CORRIGENDUM / ADDENDUM NO: 5

LOWER ARUN HYDROELECTRIC PROJECT (669 MW)

Package P1 : Construction of Adit-1 cum Spill Tunnel alongwith Spill outfall structure, Adit-2, Adit-3 & Adit-4 to HRT, HRT from STA. 100.00 m to 11865.723 m, Spill Tunnel Gate, Adit-3 Gate and Road Works etc. (DCB-CCD-LAHEP-P1-434-01).

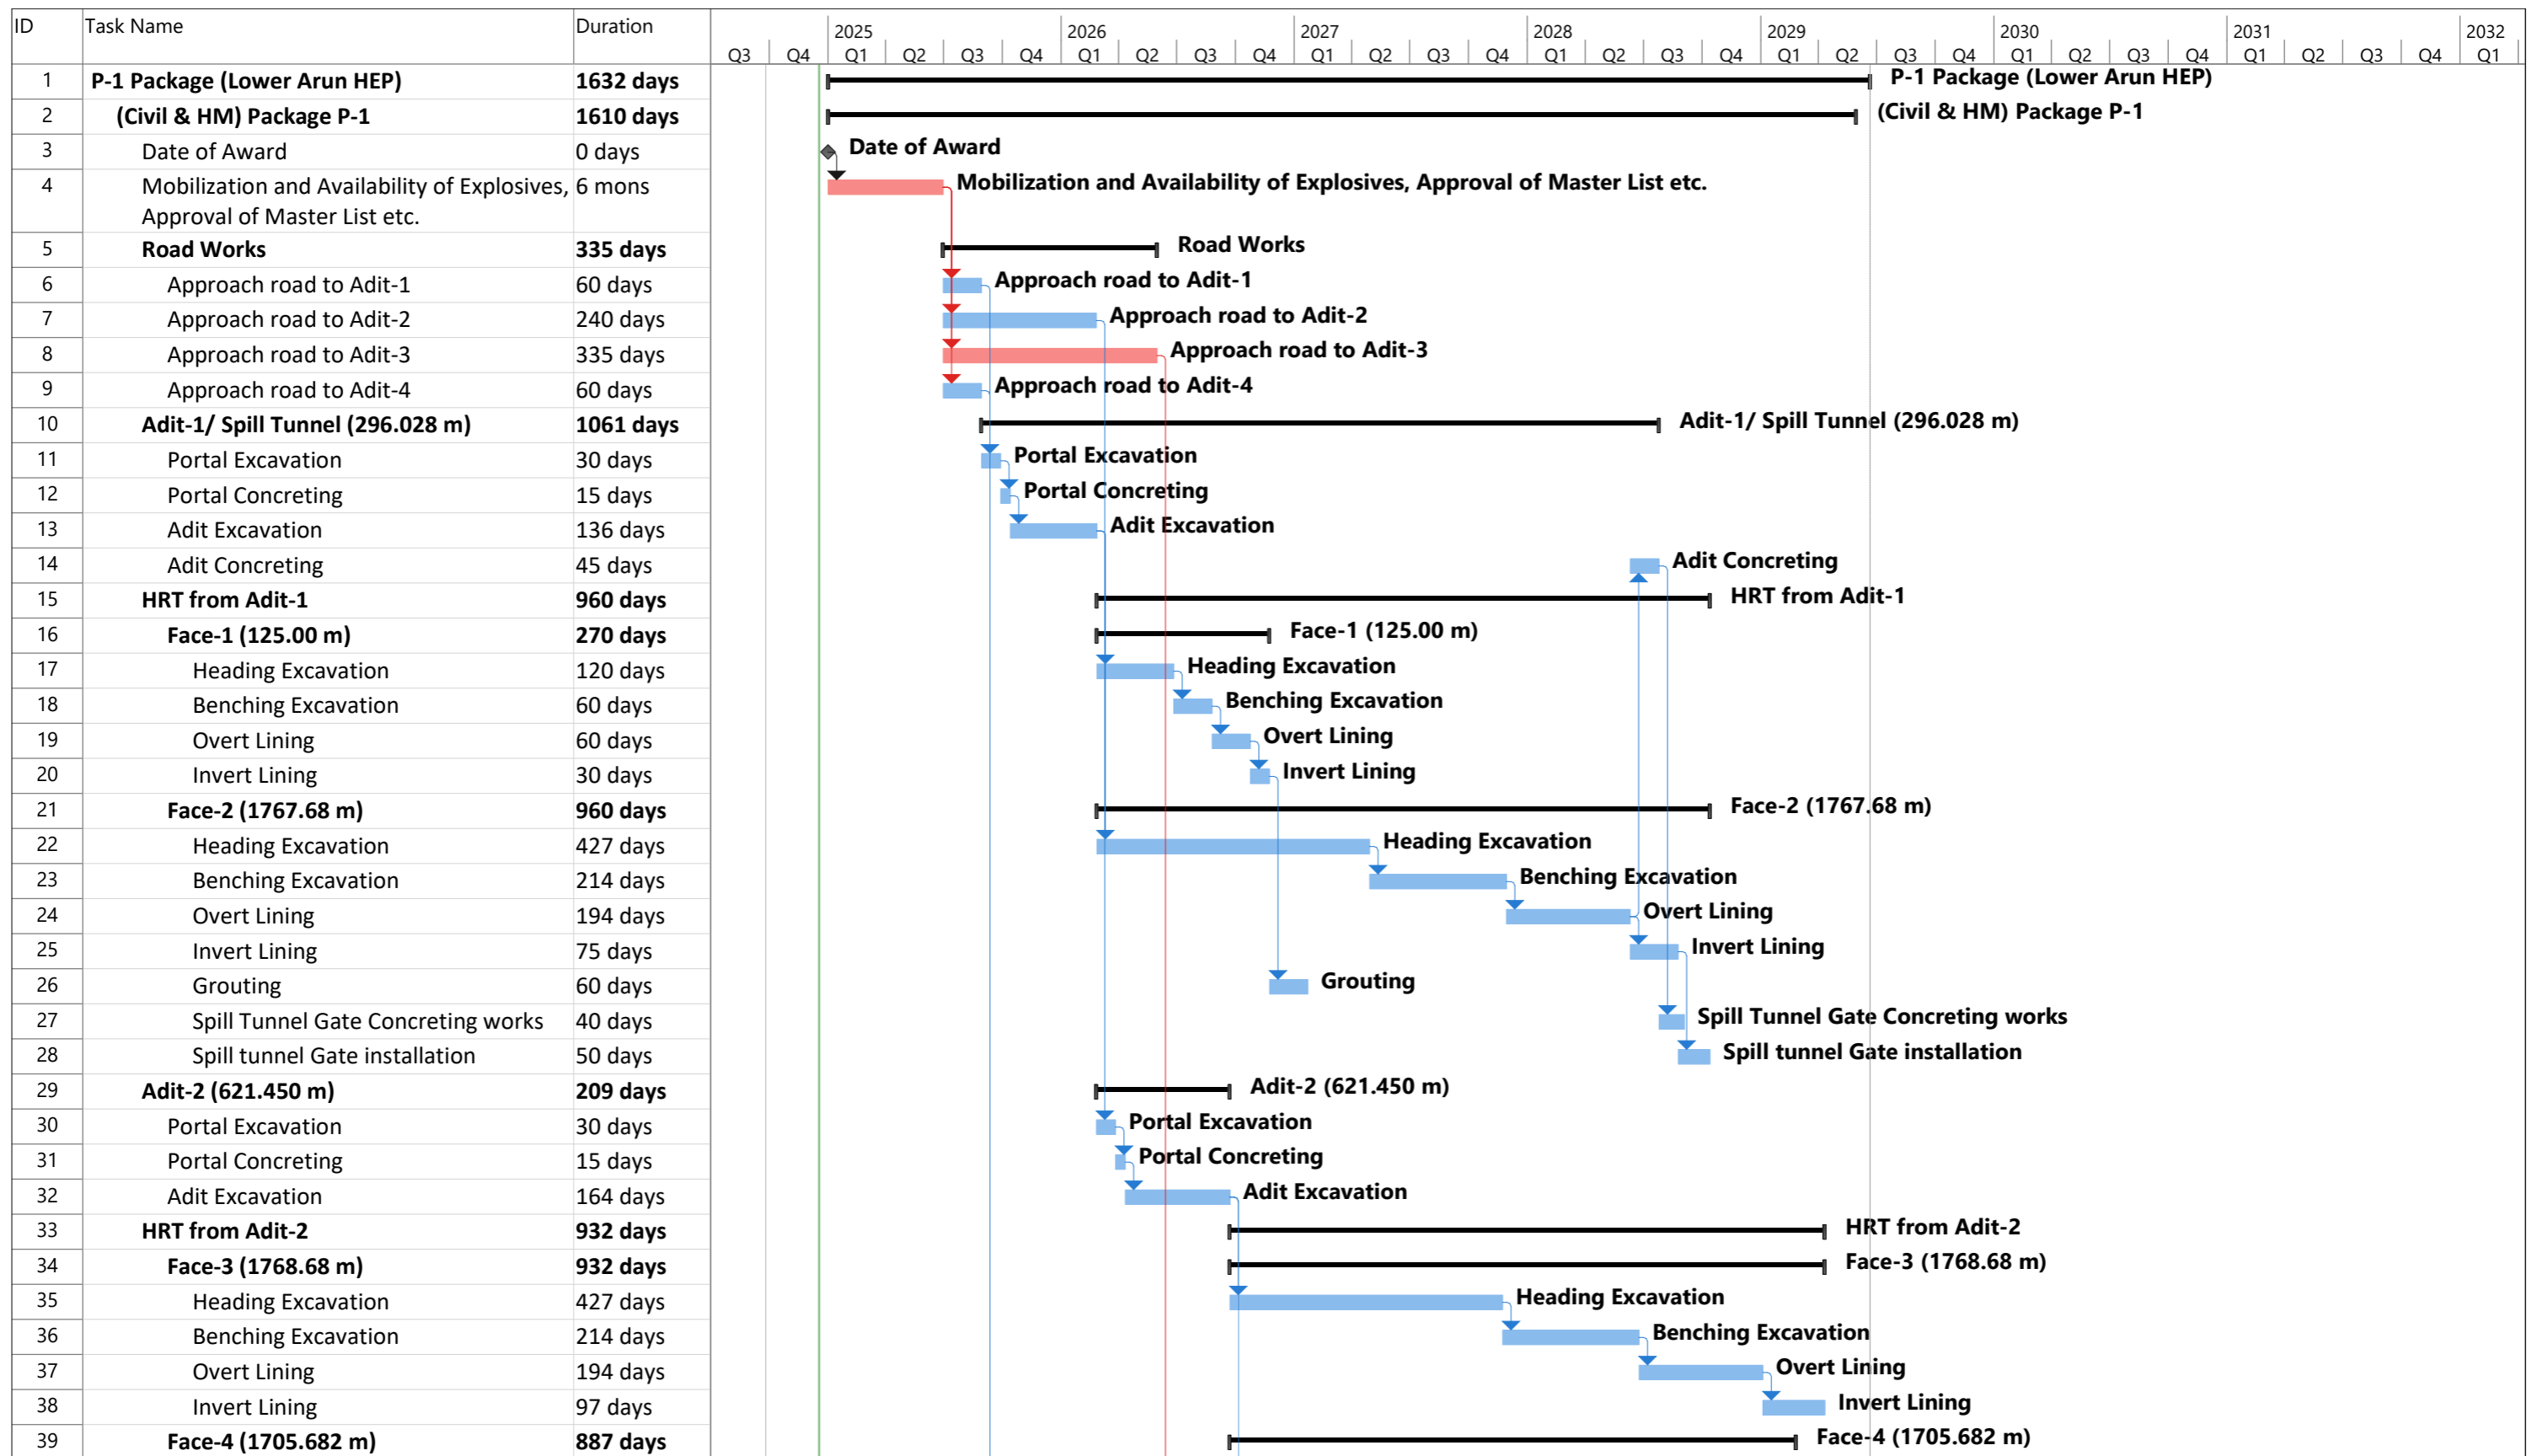
Adit-4 (DS-4)			5	Dumping site near Adit-4 (DS-4)	1.8 Km from Adit-4 portal	
					Contractor shall be required to obtain necessary approvals for dumping from various authorities at his own cost. However, at the request of contractor, Employer shall provide assistance to the Contractor for getting approvals.			
IFB 14.0 (xi)	The Contractor shall also construct residential accommodation /barrack for army security personnel at their own cost as per design / drawing by Nepal Army/Employer....				The Contractor shall also construct residential accommodation /barrack for army security personnel at his own cost as per design / drawing by Nepal Army/Employer...			
IFB 15.0	54 months including first filling of HRT, till Commissioning and testing of units.				54 months including first filling of HRT, till Commissioning and testing of units. The tentative construction schedule is attached as Annex-A.
